# MAEC TECHNICAL NEWS

No.4500-04-0206

4524 Group Notes For CNTR1 Output Auto-Control Circuit

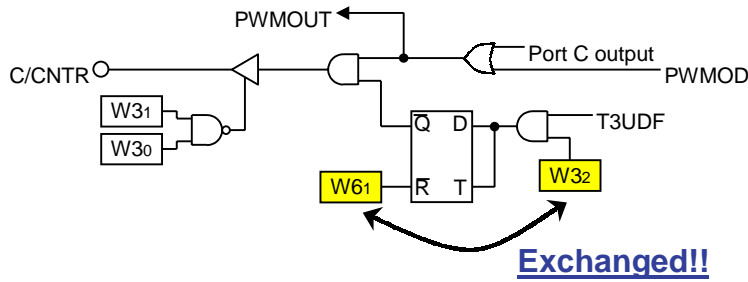
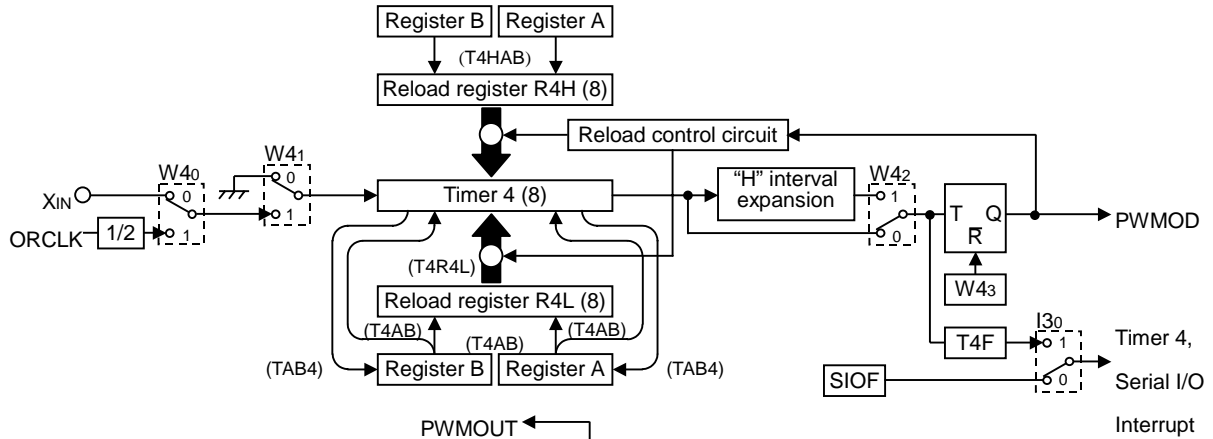
The registers W61 and W32 in a CNTR1 pin output auto-control circuit were exchanged.

Valid/invalid state of the PWM signal output to be retained when register W61 is cleared (0) is not retained by this, and this function is canceled and the output is set to be valid forcibly.

Moreover, when register W32 is cleared (0) in the state where the register W61 is set (1), the valid/invalid state of a PWM signal output is retained.

**Exchanged!!**

This error poses a problem when PWM signal output is controlled by register W61.

Please fix register W61 to "1" while the CNTR1 pin output auto-control function is used.
